National Committee on Uniform Traffic Control Devices

1
2 **National Committee on Uniform Traffic Control Devices (NCUTCD)**
3 **Recommended Changes to Proposed Text for 11th Edition of the MUTCD**
4 **Docket Number: FHWA-2020-0001**

5 **Federal Register Item Number:** 516

6 **NPA MUTCD Section Number:** Section 6P.01

617 **Figure 6P-12. Lane Closure on a Two-Lane Road using Traffic Control Signals (TA-12)**

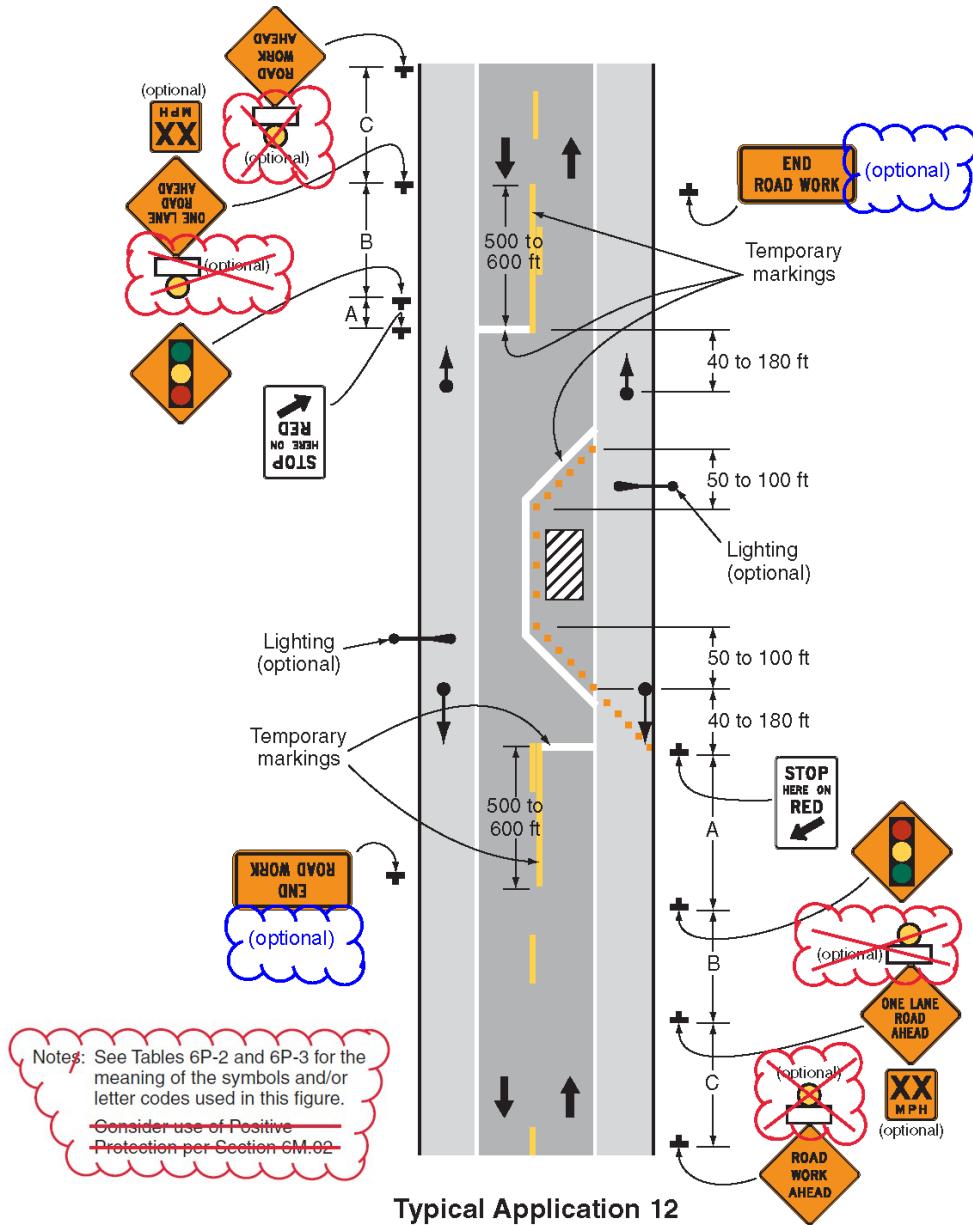
609 **Figure 6P-12 Comments:** NCUTCD generally agrees with Figure 6P-12 as presented in the
610 NPA, but recommends the following in accordance with NCUTCD recommendation 20B-TTC-
611 02:

Figure 6P-13. Temporary Road Closure (TA-13)

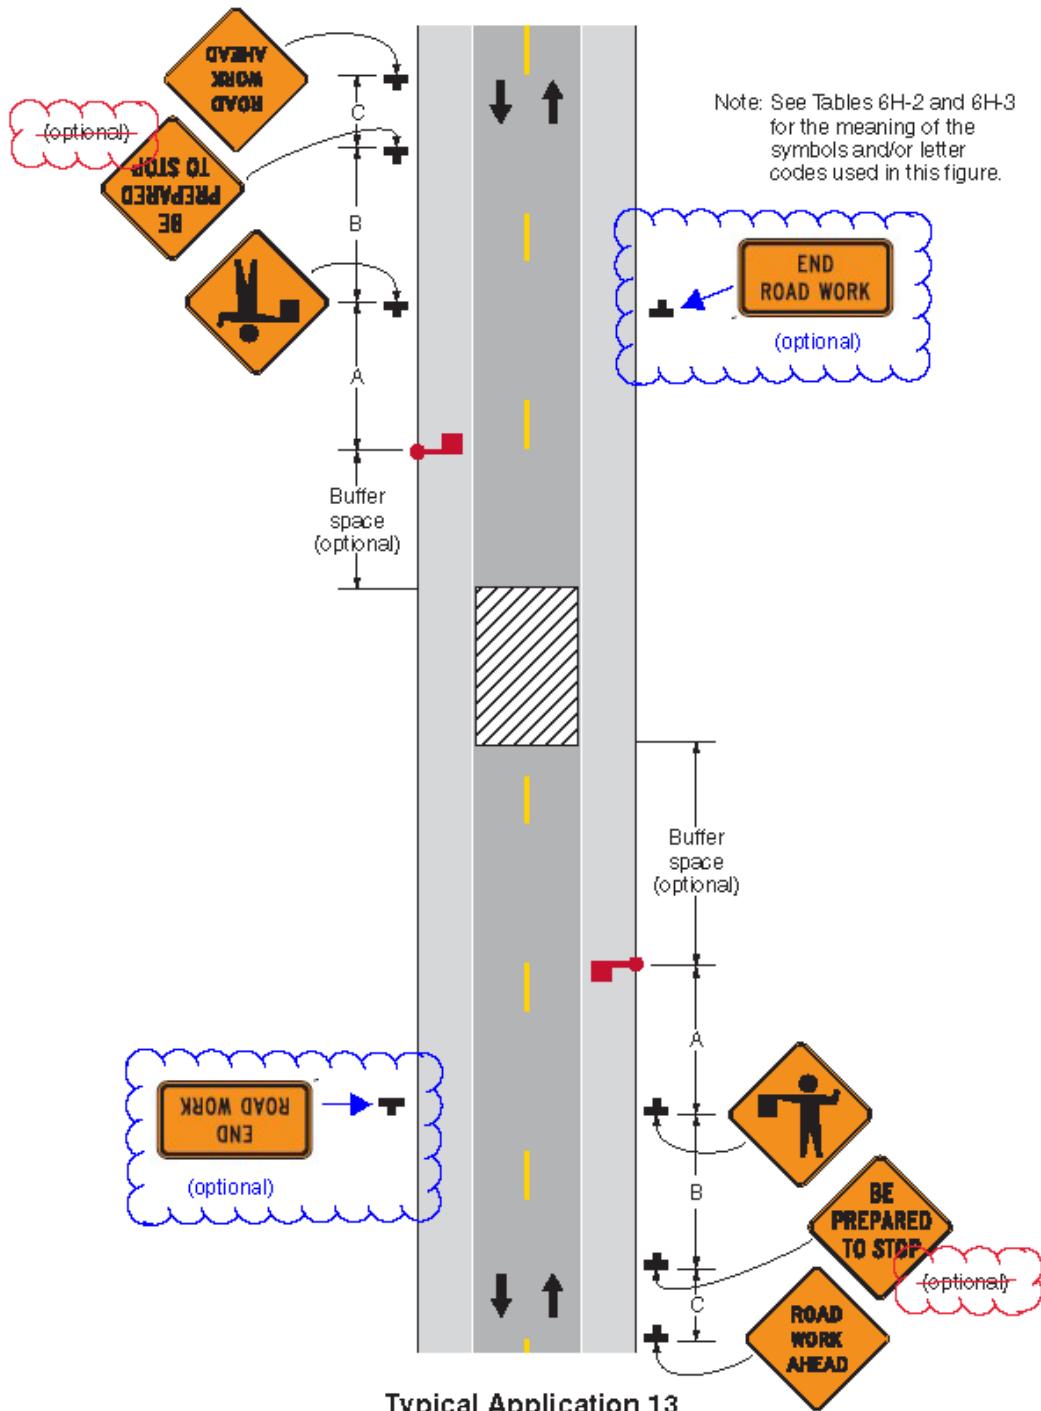
646 **Figure 6P-13 Comments:** NCUTCD generally agrees with Figure 6P-13 as presented in the
647 NPA, but recommends adding “optional” to signs as appropriate in accordance with NCUTCD
648 recommendation 20B-TTC-02.

Figure 6P-14. Haul Road Crossing (TA-14)

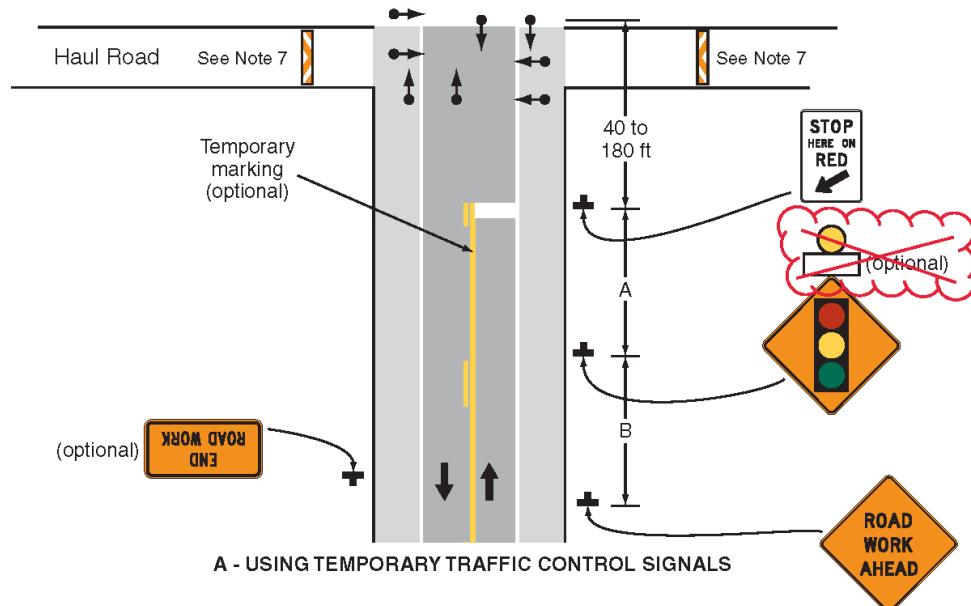
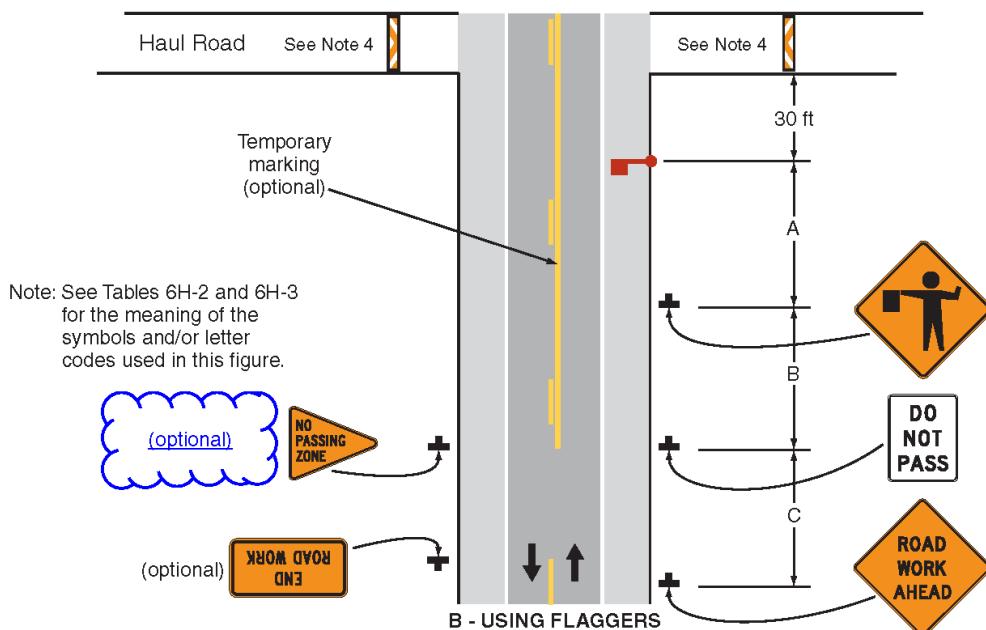
701
702 **Figure 6P-14 Comments:** NCUTCD generally agrees with Figure 6P-14 as presented in the
703 NPA, but recommends deleting warning lights and adding “optional” to signs as appropriate in
accordance with NCUTCD recommendation 20B-TTC-02.

760 **Figure 6P-15. Work in the Center of a Road with Low Traffic Volumes (TA-15)**

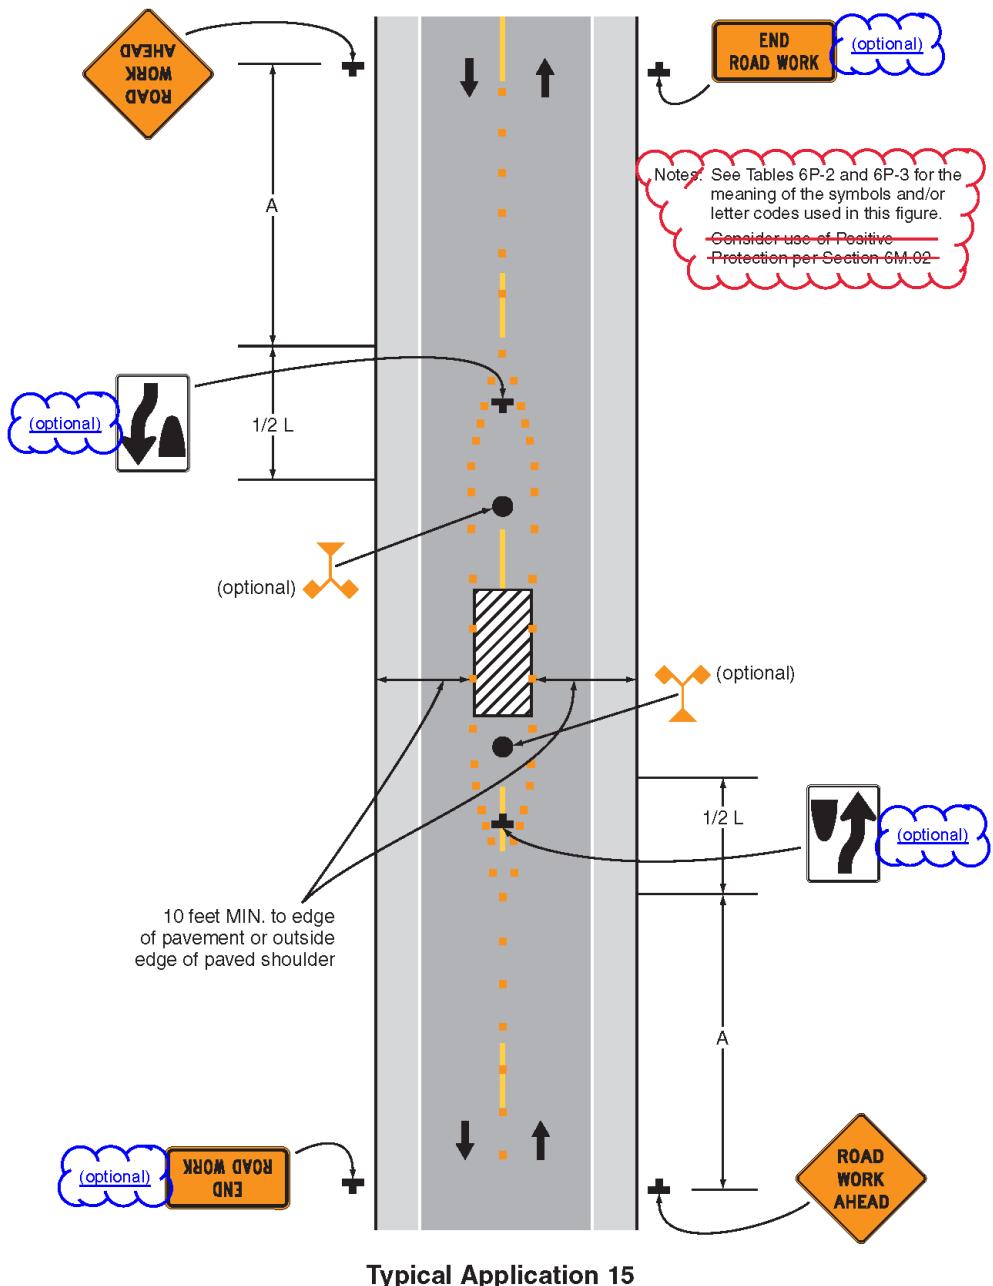
754 **Figure 6P-15 Comments:** NCUTCD generally agrees with Figure 6P-15 as presented in the
755 NPA, but recommends the following in accordance with NCUTCD recommendation 20B-TTC-
756 02:

797
798 **Figure 6P-16. Surveying Along the Center Line of a Road**
799 **with Low Traffic Volumes (TA-16)**

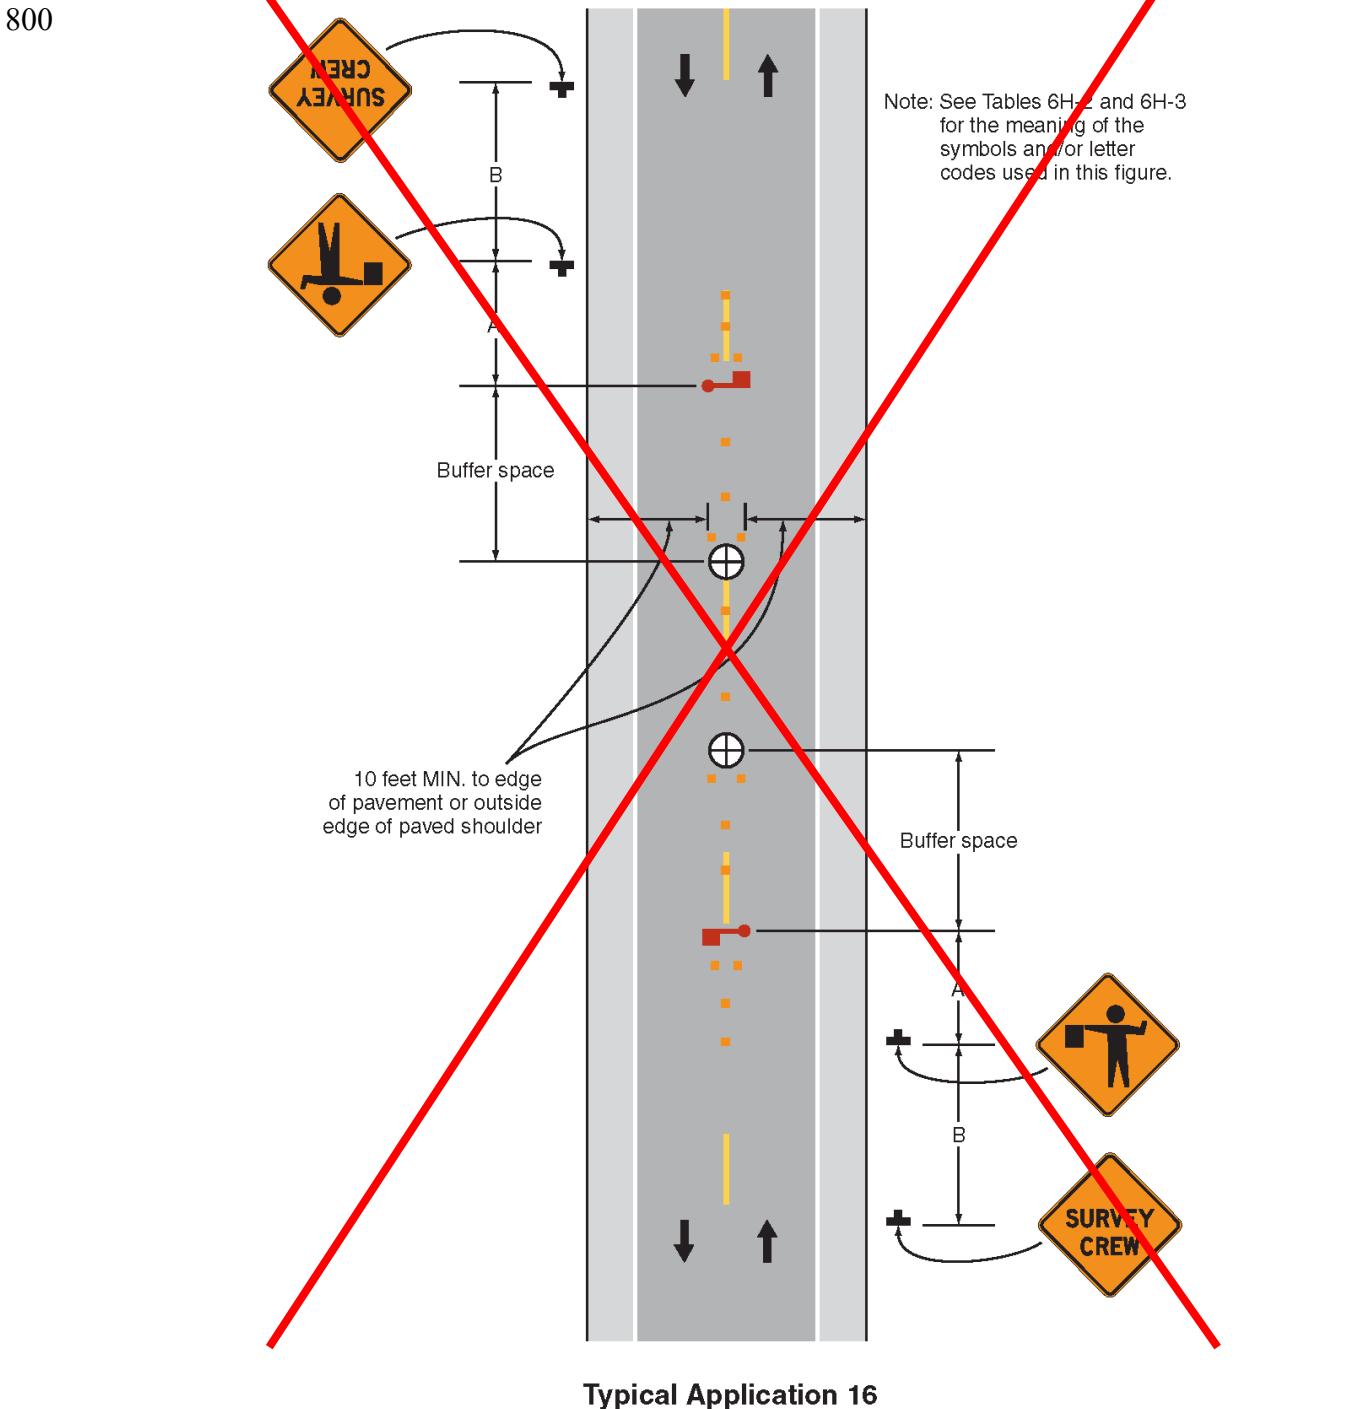
794 **Figure 6P-16 Comment:** NCUTCD recommends deleting this Typical Application entirely and
795 combining it with Typical Application 15 in accordance with NCUTCD recommendation 20B-
796 TTC-02.

845
846 **Figure 6P-17. Mobile Operations on a Two-Lane Road (TA-17)**
847

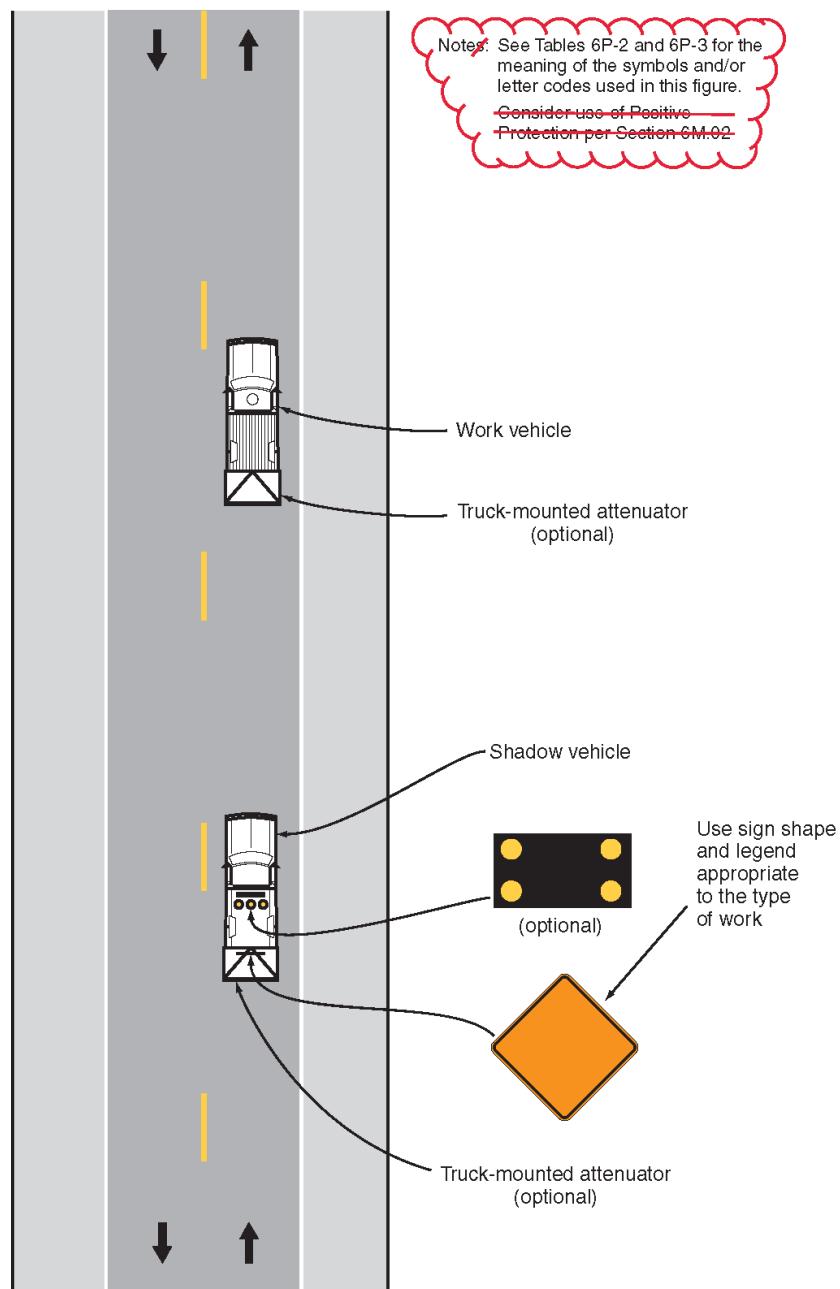
842 **Figure 6P-17 Comments:** NCUTCD generally agrees with Figure 6P-17 as presented in the
843 NPA, but recommends deleting the positive protection note since it is redundant with a note
844 added to the notes page.

970 **Figure 6P-21. Lane Closure on the Near Side of an Intersection (TA-21)**

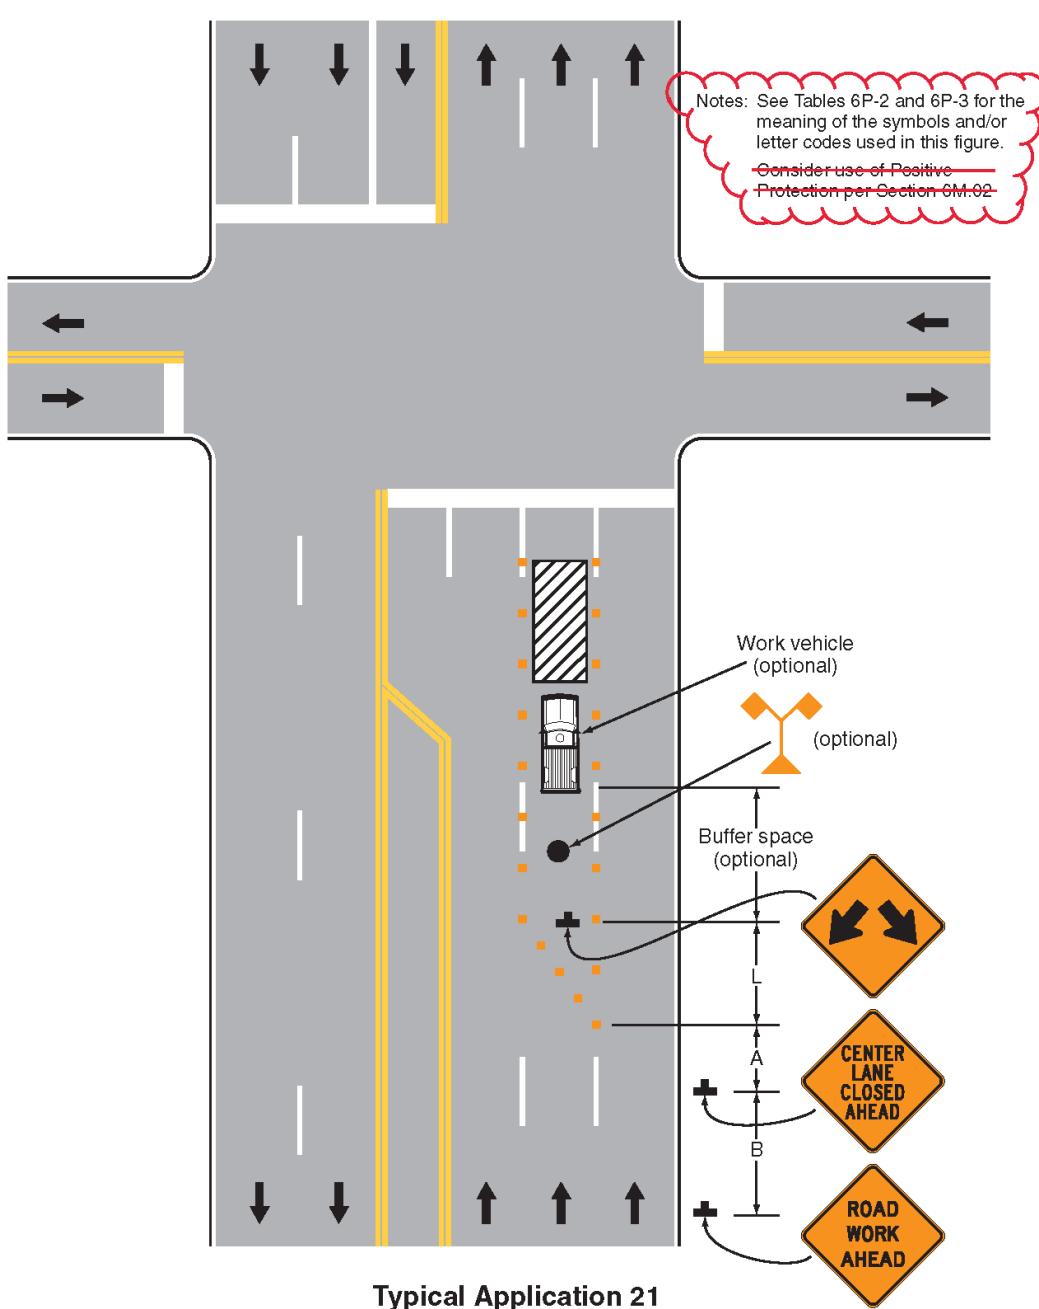
966 **Figure 6P-21 Comments:** NCUTCD generally agrees with Figure 6P-21 as presented in the
967 NPA, but recommends deleting the positive protection note since it is redundant with a note
968 added to the notes page.

Figure 6P-22. Lane Closure on the Far Side of an Intersection (TA-22)

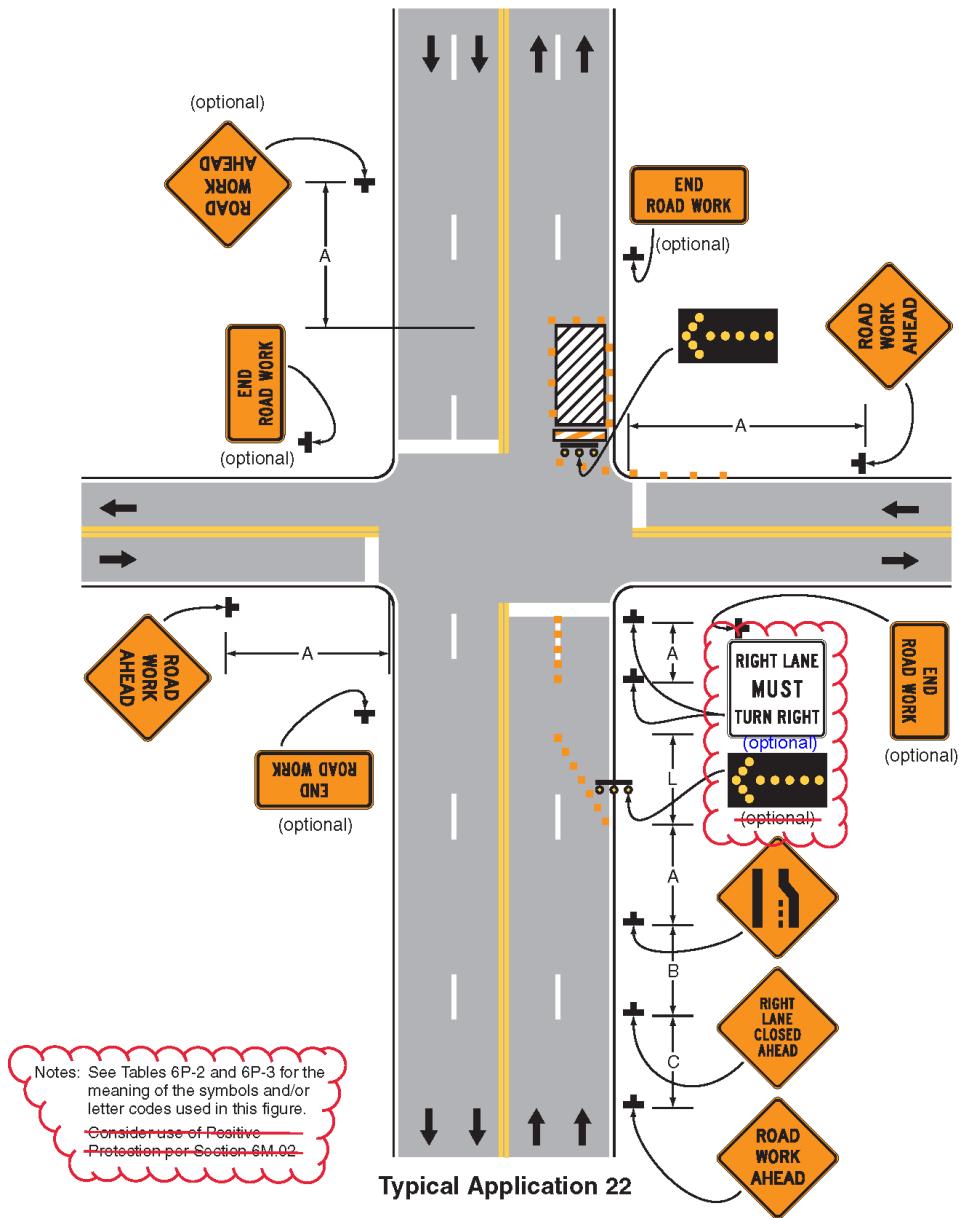
1004 **Figure 6P-22 Comments:** NCUTCD generally agrees with Figure 6P-22 as presented in the
1005 NPA, but recommends revising as follows:
1006

- Delete the positive protection note since it is redundant with a note added to the notes
1007 page
- Relocate the “(optional)” text from under the arrow board to be under the RIGHT LANE
1008 MUST TURN RIGHT sign
- 1009
- 1010
- 1011
- 1012
